DEVELOPMENT APPLICATION ASSESSMENT REPORT

Application Number:	DA2022/0646
----------------------------	-------------

Responsible Officer:	Alex Keller
Land to be developed (Address):	Lot 5 DP 16941, 124 Queenscliff Road QUEENSCLIFF NSW 2096 Lot 6 DP 16941, 122 Queenscliff Road QUEENSCLIFF NSW 2096
Proposed Development:	Demolition works and construction of a residential flat building
Zoning:	Warringah LEP2011 - Land zoned R2 Low Density Residential
Development Permissible:	No
Existing Use Rights:	Yes
Consent Authority:	Northern Beaches Council
Delegation Level:	NBLPP
Land and Environment Court Action:	No
Owner:	Gemini Queenscliff Pty Limited
Applicant:	Kristoffer Allan Harvey

Image: Height plane blanket from existing ground level in relation to 8.5m height limit (blue) for the proposed building.

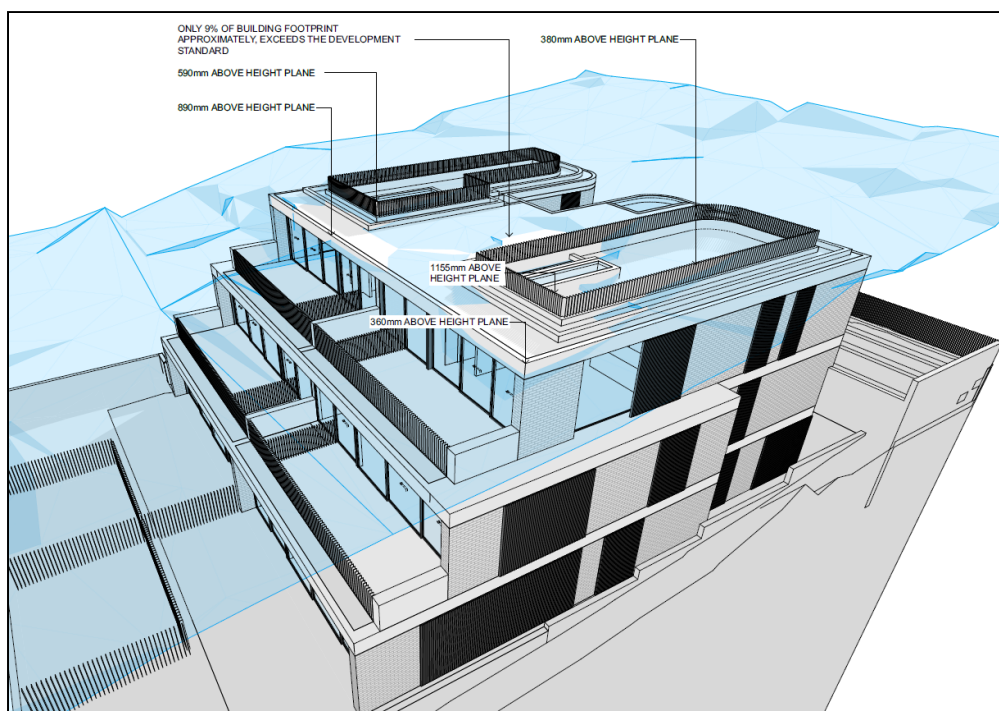
The development application is made pursuant to the existing use rights provisions of the EPA Act and under established precedent made in the NSW *Land & Environment Court* the development standards in WLEP 2011 are not deemed to strictly apply. A detailed height plane from survey data has been provided to show the building complies with the building height plane measured from Existing Ground Level (EGL).

Image: Height plane variation for building elements above existing ground level.

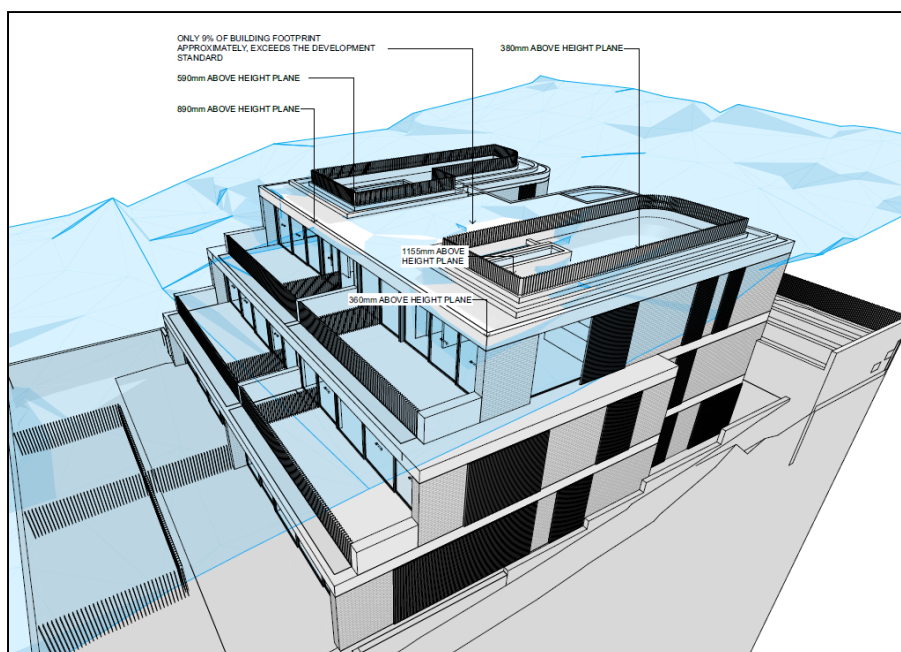
Development standard:	Building Height
Requirement:	8.5m
Proposed:	9.65m
Percentage variation to requirement:	13.5% (1.15m)

The diagram below shows the non-compliance in association with existing ground level along the forward roof edge (upper storey) and corner and mid section above the 8.5m height plane. The highest element being the fence element around the outer edge of the roof terrace, whereas the main roof structure is generally below the height plane (blue).

Image: Wall height and streetscape presentation in context with ground levels and visual impact with adjacent dwellings outlined.

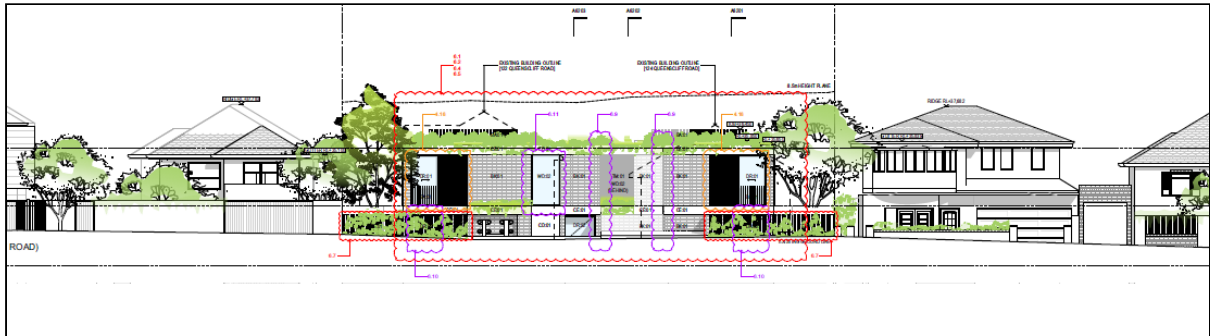
The non-compliance with the wall height control is subject to the existing ground line that varies and steps up across parts of the site, however the proposal will demolish and regrade the site levels for landscaping works (including excavate). The proposal will present as 2 storey to the street with a compliant wall height to the public domain. At the street frontage the building sits 5.7m above existing ground level for the habitable floor to upper ceiling. Along the side and rear the non-compliance is influenced by the slope of the land combined with 2.7m (ADG compliant) floor to ceiling and slab thickness of 0.4m that create an overall higher wall height plane toward the southern side of the building. Amendments have been made to the plans to increase

setbacks along the side walls as well as to provide articulation and visual interest to the wall plane (screens, windows etc). When viewed from a distance such as from Manly lagoon area teneally the building is sits below the backdrop of higher buildings along Queenscliff Road and is consistent with the height / scale and density of surrounding dwellings. Landscape elements are included for the rear and side elevations to break up the southern wall massing / setback zone. The wall height will not create an unreasonable visual impact on surrounding land, or public areas.

Image: West elevation demonstrating side boundary envelope and 8.5m height line.

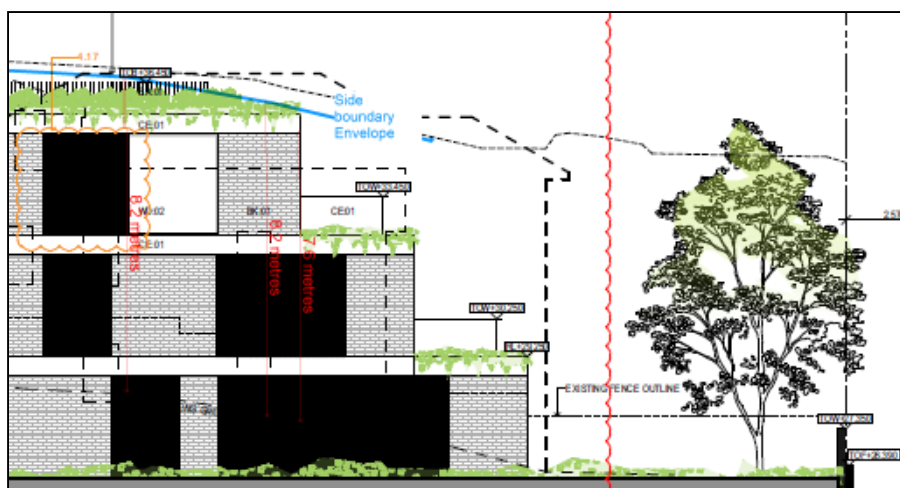
Adequate physical separation is achieved between buildings through the articulation and minor stepping in of the upper level (up to 3.3m for the top level) and at mid level sections which combined with privacy screens, ensures no unreasonable loss of privacy or unreasonable solar amenity impacts on the adjoining land. Submitted shadow diagrams (Drawing No.A2603 dated 20.3.2023) demonstrate compliant solar sunlight is provided to adjoining properties pursuant to Warringah DCP. However, it is noted that this is attributed to space that contains the swimming pool of No.120 Queenscliff Road and therefore not purposeful. Side elevation (wall shadow) diagrams provide additional representation to solar access for living area decks and windows that allow for direct sunlight to internal living space. The proposal is consistent with this objective having consideration to the south facing slope and self shadow of adjacent dwellings.

Images of solar access at 11:30, 21 June and 3pm for No.120 Queenscliff Road.

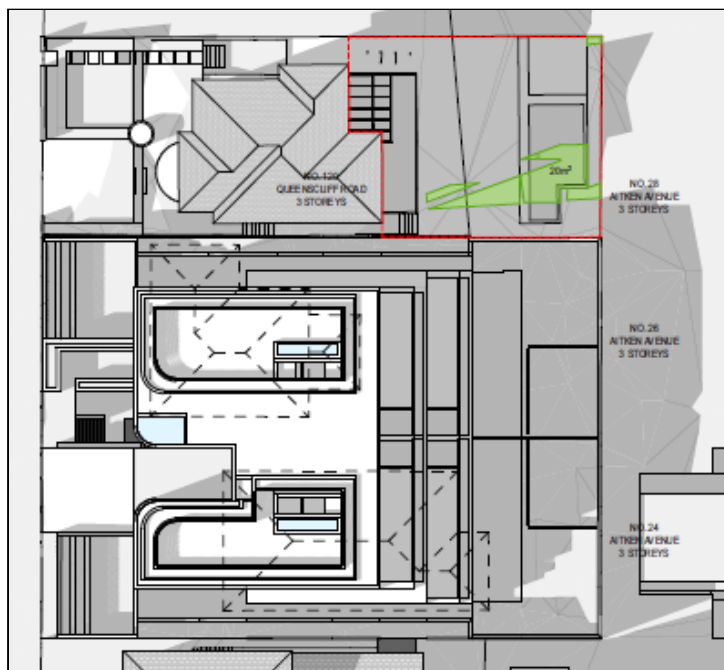
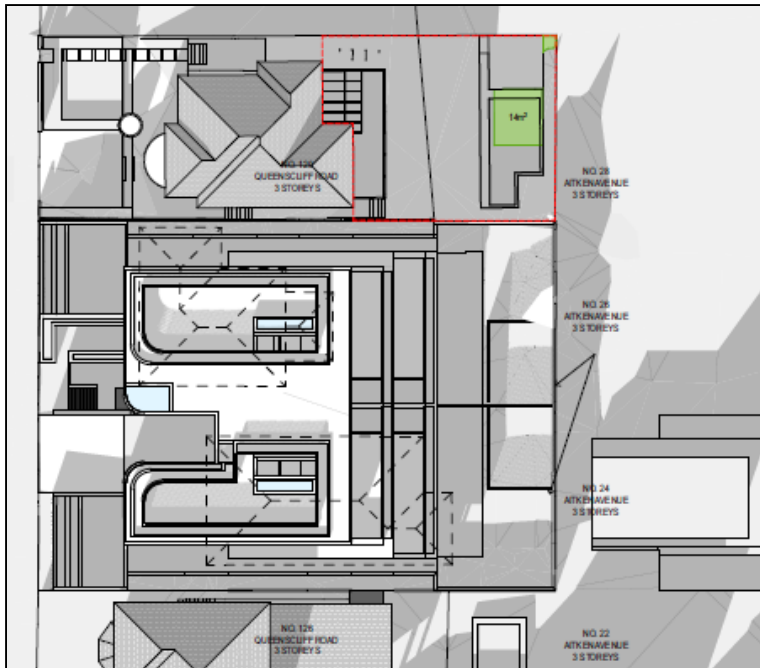
Image: Side wall elevation impact begins around 11:30 to fall toward No.120 Queenscliff Road. At 3pm most side wall in shade with lower deck in shade and upper level part shade. At ground level majority rear yard in shade except for part of pool surface as can be seen below in plan view:

Image: "Sun Eye" view to adjacent properties and solar access within the development at 9am and 3pm on 21 June.

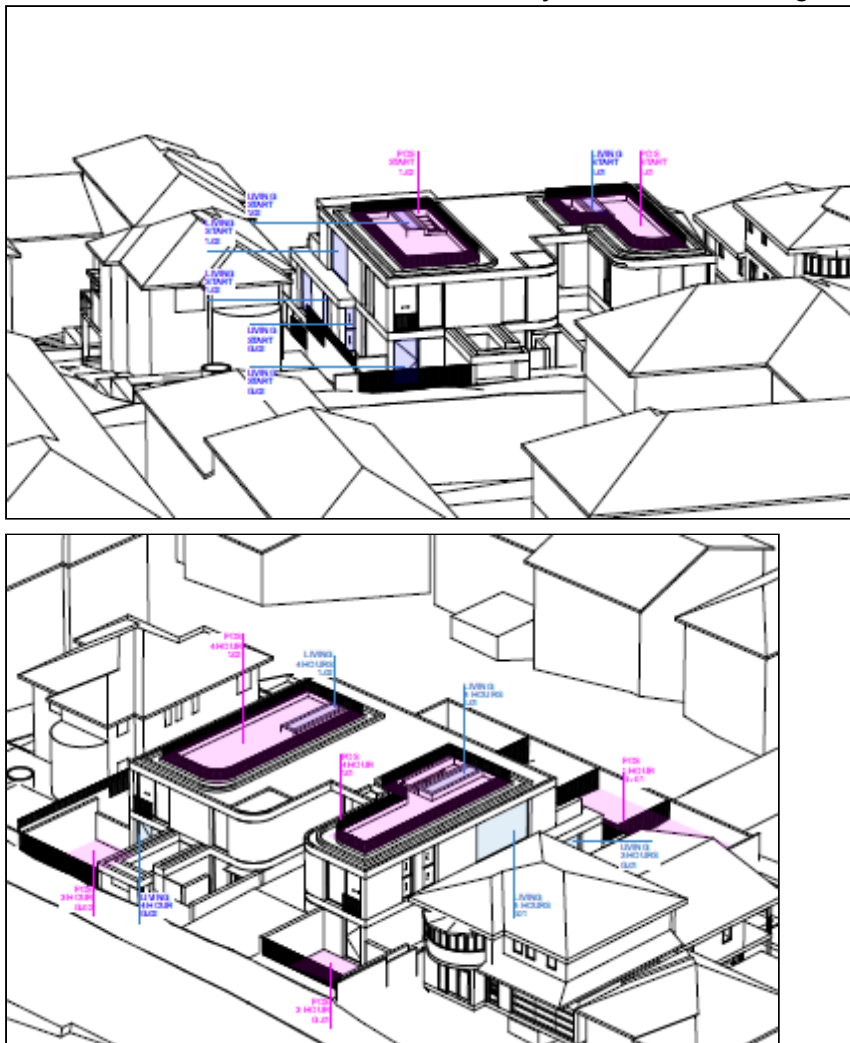
The design of the proposal provides a suitable flat roof form that ensures no unreasonable impact on the need for artificial lighting given the density and pattern of surrounding development, consistency with the built form controls (acceptability of some reduction in solar access for new buildings) and circumstances of the existing site constraints. "Sun-eye view"

images are provided for hourly intervals between 9am and 3pm to demonstrate solar access across the site and for the rear POS of adjacent land including building structures.

Image: Street level view through the site obscured by existing pattern of development.

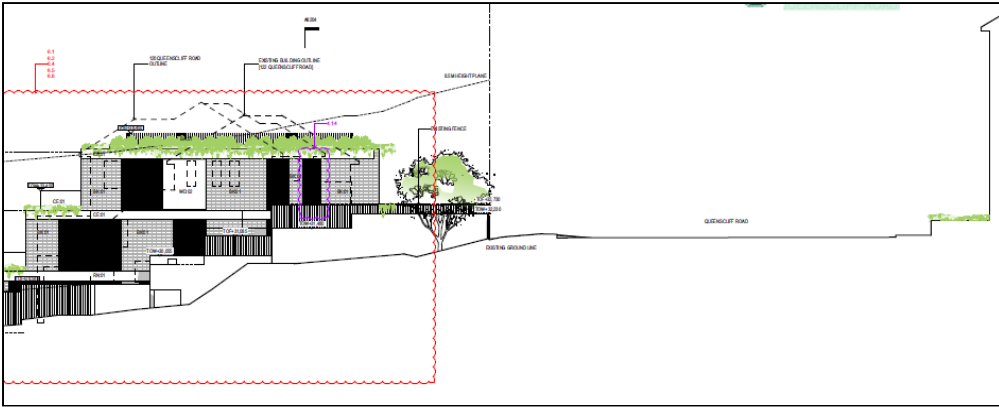
A detailed inspection within no.120 Queenscliff Road was conducted, including general viewing of the surrounding area from accessible vantage points along the street and within the site to consider various views across the site and for the broad surroundings as a whole. Properties on the north side of Queenscliff Road are at least in proximity of RL37 to RL40 at floor levels 2 and 3 which enable views over the subject proposal (being maximum height at RL36.4). At ground level (generally garages) and first floor for properties on the northern side of Queenscliff Road there is no significant loss or gain in views. Overall the lower profile flat roof proposed views are generally consistent in terms of the qualitative view as a whole when looking southward over the site as demonstrated in the street image below.
